ADDENDUM #1 – Longmeadow Road and Ole Musket Road Drainage Improvements

To: All Bidders
From: Gorrill Palmer
Date: July 7, 2022
Subject: **3656** – Longmeadow Road and Ole Musket Road Drainage Improvements

C102

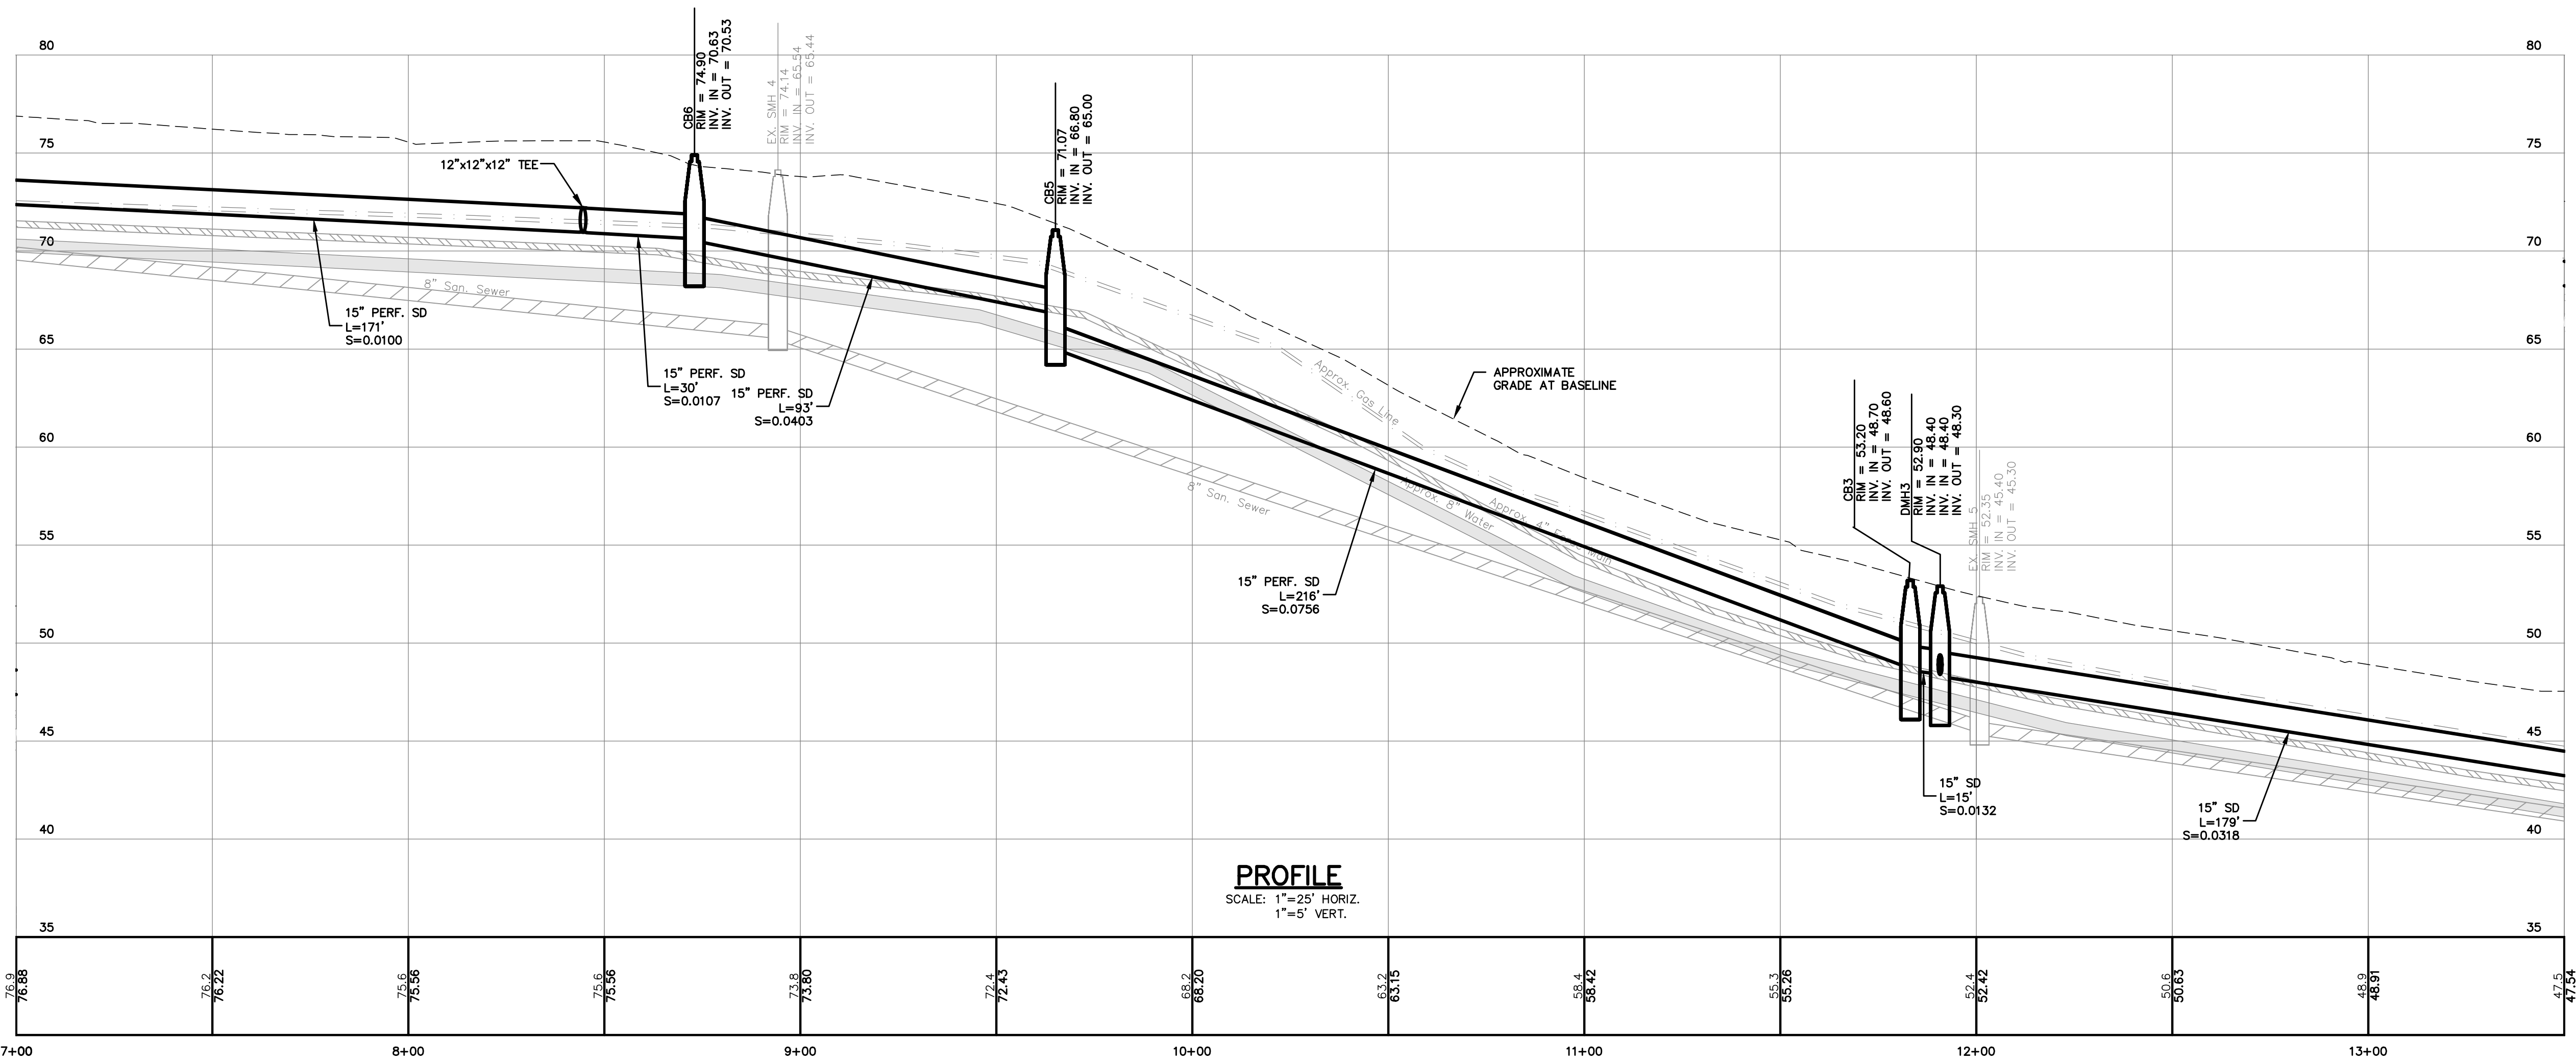
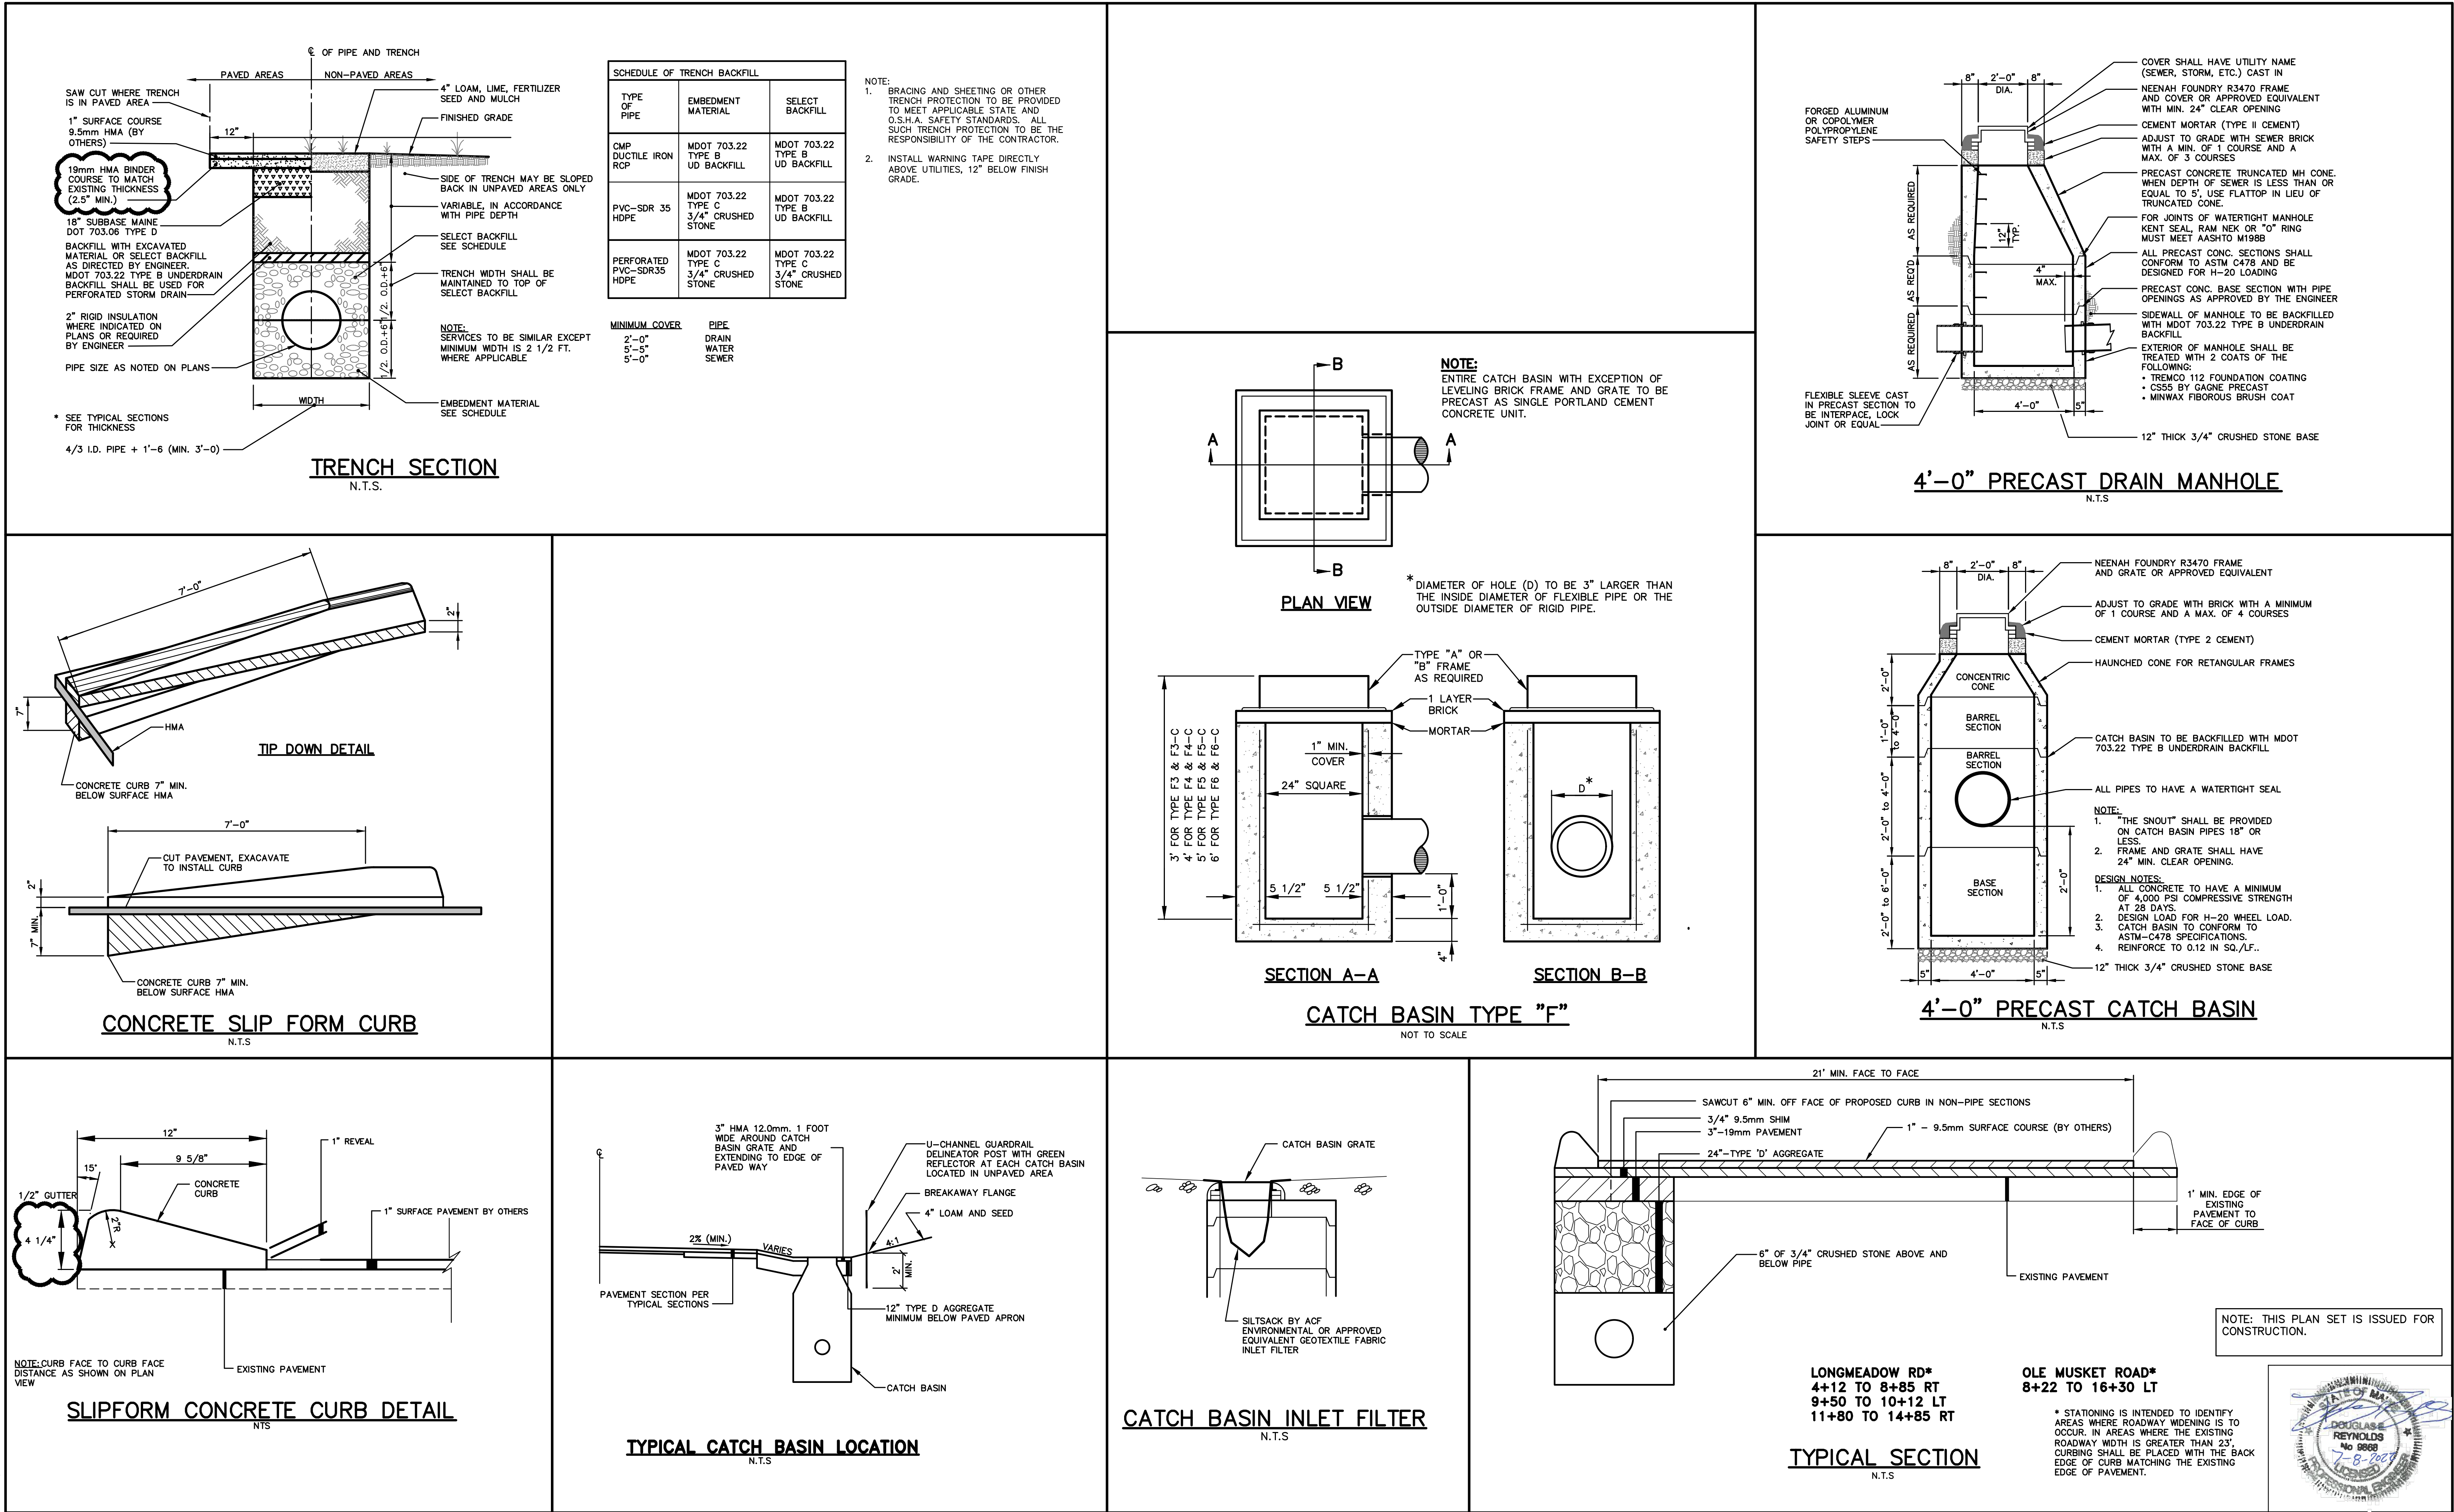
*A revised C107 Sheet is included with this addendum
2. Drawing No. C102, Longmeadow Drive Plan and Profile – This drawing has been modified as follows:
 - a. Note added for tree removal at STA 10+40 left

*A revised C102 Sheet is included with this addendum

- I. Drawing No. C107, Drainage Details – This drawing has been modified as follows:
 - a. Removal of “The Snout” detail as it is not necessary for this project.
 - b. Updated Slipform Concrete Curb Detail to have a total height of 4 1/4”
 - c. Updated Trench Section Detail to 2 1/2” thickness on the 19mm HMA Binder Course detail VS. “4” MAX.”
